Date: 05-23-19

RE: Addendum No. 1 to the Bidding Documents for Diesel Lab Ventilation Upgrades at the Mailman Trades Building, Northern Maine Community College

MD-100

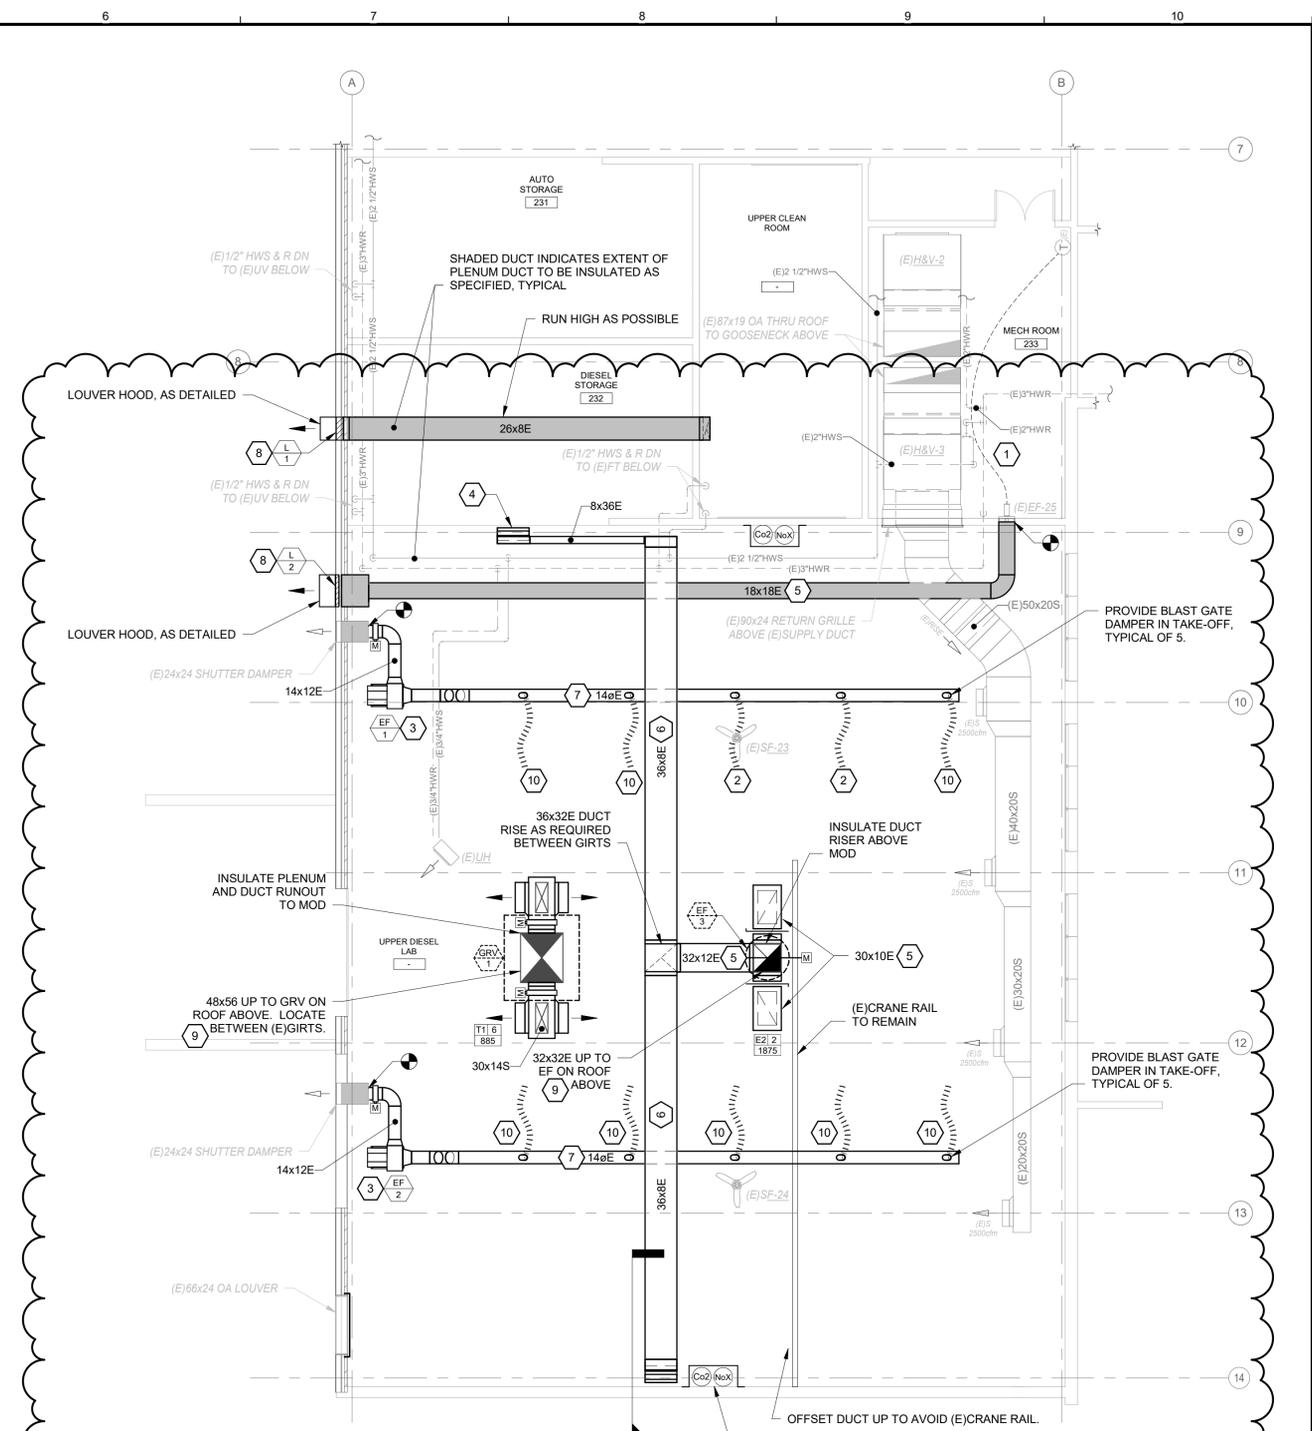
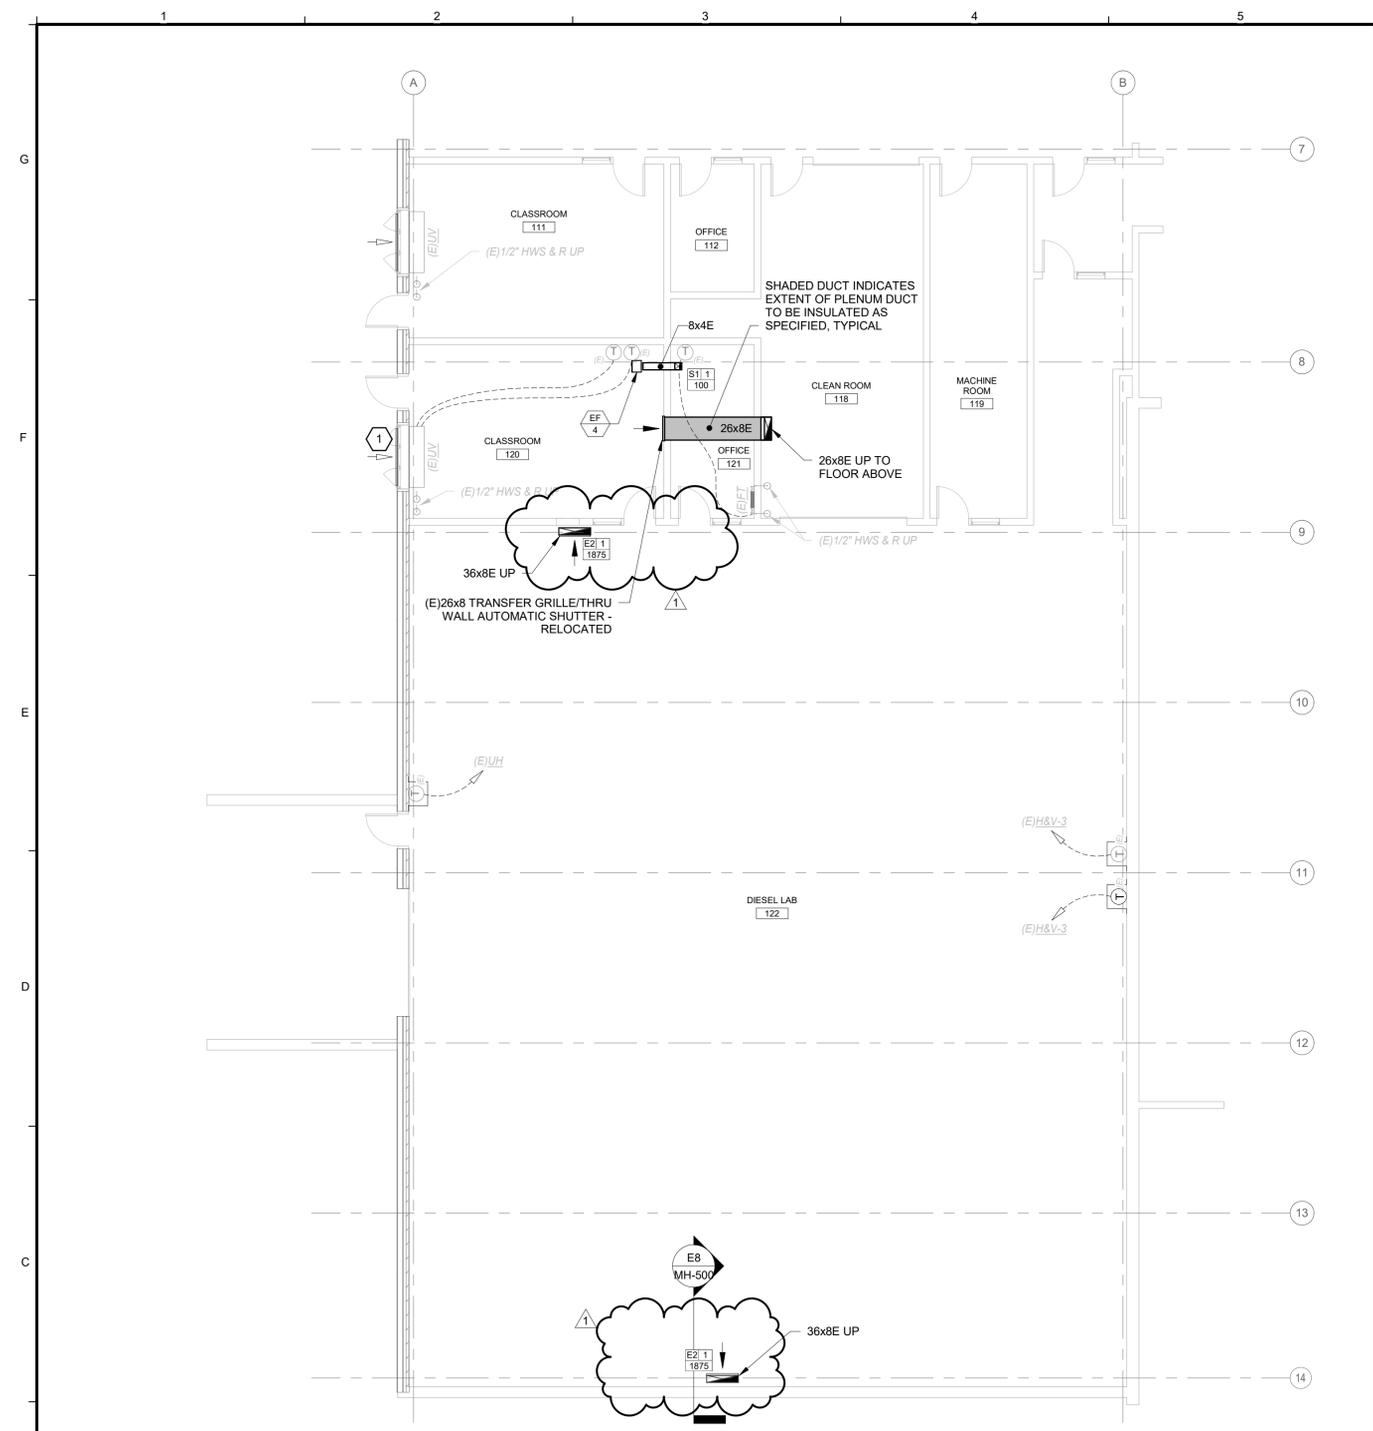
- 1 REFER TO SPECIFICATION SECTION 230993 FOR MODIFICATIONS TO THE CURRENT OPERATING SEQUENCE OF EXISTING EQUIPMENT.
- 2 UNDER THE BASE BID, EXISTING FLEX HOSE SHALL REMAIN. FURNISH BLAST GATE AT CONNECTION TO NEW MAIN. LOCK EXISTING BLAST GATE DAMPER OPEN. UNDER ALTERNATE No. 1, REPLACE THE EXISTING HOSE AND EXHAUST ADAPTER AS NOTED IN KEYED NOTE No. 10 BELOW.

- 3 SUSPEND FAN FROM STRUCTURE ABOVE, VIA INSTRUT BASE RAILS SUSPENDED USING 1/2" RODS AT EACH END OF EACH RAIL.
- 4 OFFSET 8x36E DUCT AS INDICATED TO AVOID EXISTING BEAM/EXISTING CLASSROOM DOOR BELOW. DROP DOWN FACE OF WALL TO LOW EXHAUST GRILLE. MOUNT GRILLE 2'-0" ABOVE FINISHED FLOOR.

- 5 RUN DUCT HIGH AS POSSIBLE, TIGHT TO UNDERSIDE OF EXISTING GIRTS.
- 6 RUN DUCT UP TIGHT TO UNDERSIDE OF ROOF DECK, ABOVE STEEL BEAMS, BETWEEN EXISTING GIRTS.

- 7 RUN DUCT HIGH AS POSSIBLE, TIGHT TO UNDERSIDE OF EXISTING GIRTS.
- 8 FRAME OPENINGS w/600S200-43 MEMBER, ALL 4 SIDES. CONNECT EACH MEMBER w/TSN AL 325 w/(3)FASTENERS EACH LEG (MINIMUM). REFER TO ARCHITECTURAL PLANS FOR MOUNTING REQUIREMENTS.

- 9 FRAME OPENINGS PER DETAIL F5 - SHEET MH500.
- 10 FURNISH AND INSTALL NEW HIGH TEMPERATURE VEHICLE EXHAUST HOSE (VENTAIRE HTN) WITH EXHAUST ADAPTERS. REFER TO OVERHEAD, NON-DISAPPEARING HOSE DETAIL ON SHEET MH-500 FOR DETAILS AND ACCESSORIES. FURNISH AND INSTALL A MANUAL CABLE/PULLEY RETRACTION SYSTEM WITH CABLE TERMINATIONS AT THE NORTH AND SOUTH WALLS.

MH-500

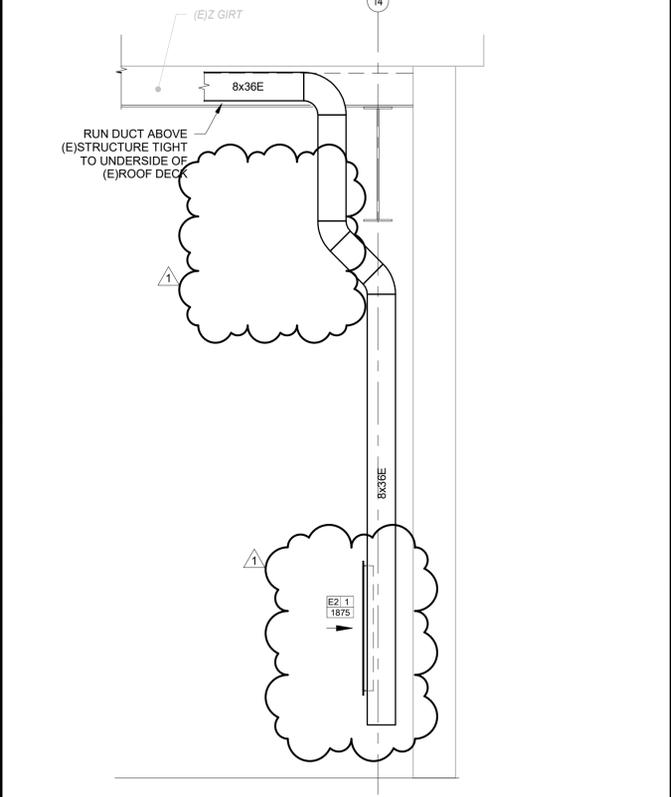
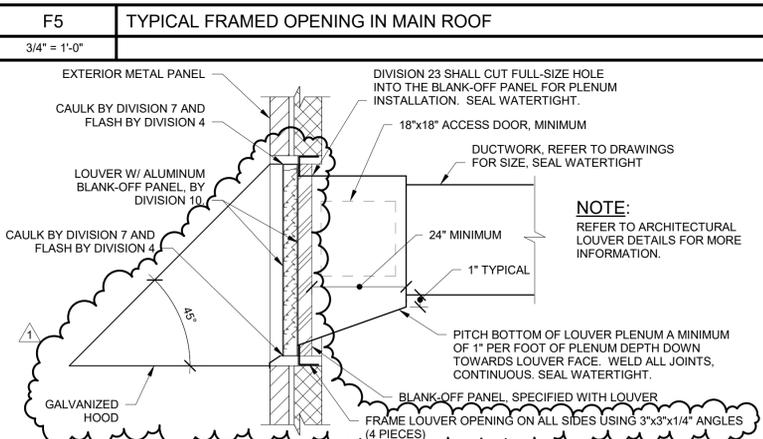
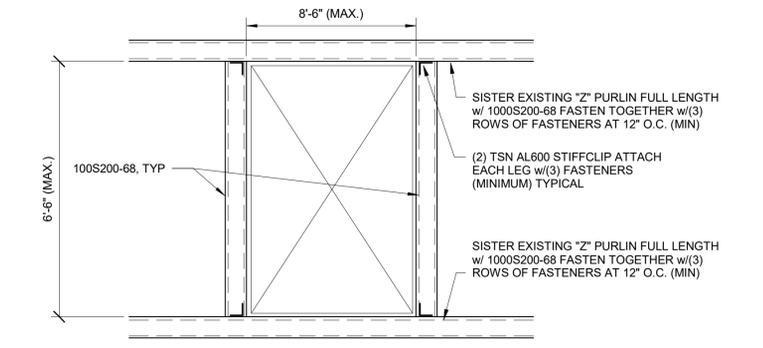
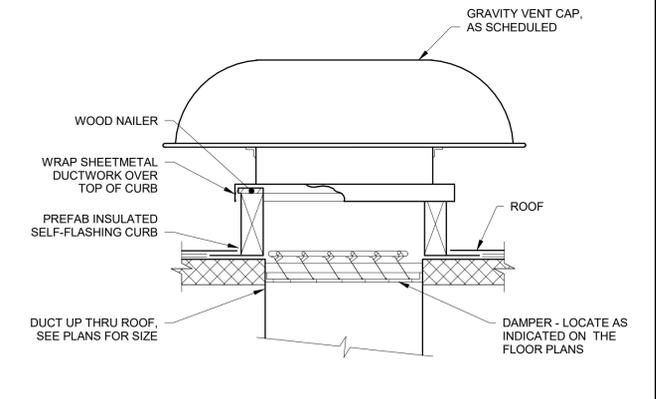
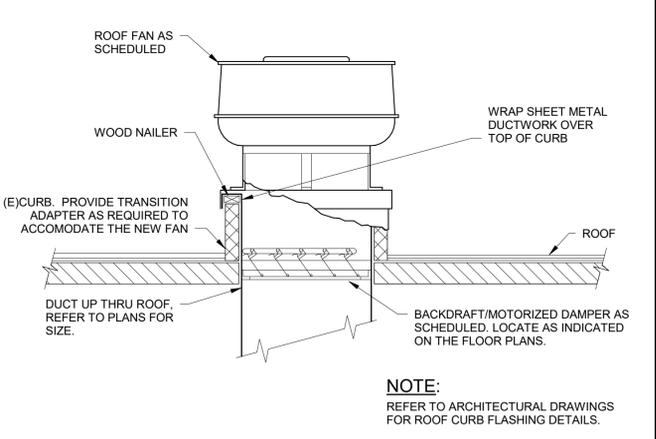
NOTE: TAILPIPE ADAPTERS SHALL INCLUDE BUMPER HOOK, SPRING CLIP AND GAS ANALYZER SLOT. STACK ADAPTERS SHALL INCLUDE POSITIONING HOOK, STACK GUIDE STOP AND RAIN CAP OPENER.
EXHAUST ADAPTER: - UNDER THE BASE BID FURNISH AND INSTALL: (2) TAILPIPE ADAPTERS - VENTAIRE MODEL TG (6) STACK ADAPTERS - VENTAIRE MODEL DSG - UNDER ALTERNATE No. 1 FURNISH AND INSTALL: (2) ADDITIONAL VENTAIRE MODEL DSG STACK ADAPTERS

1. PROVIDE ADAPTER CURB TO REDUCE THE EXISTING CURB COPENING (APPROXIMATELY 40"x40") TO MATCH THE NEW FAN REQUIREMENTS.
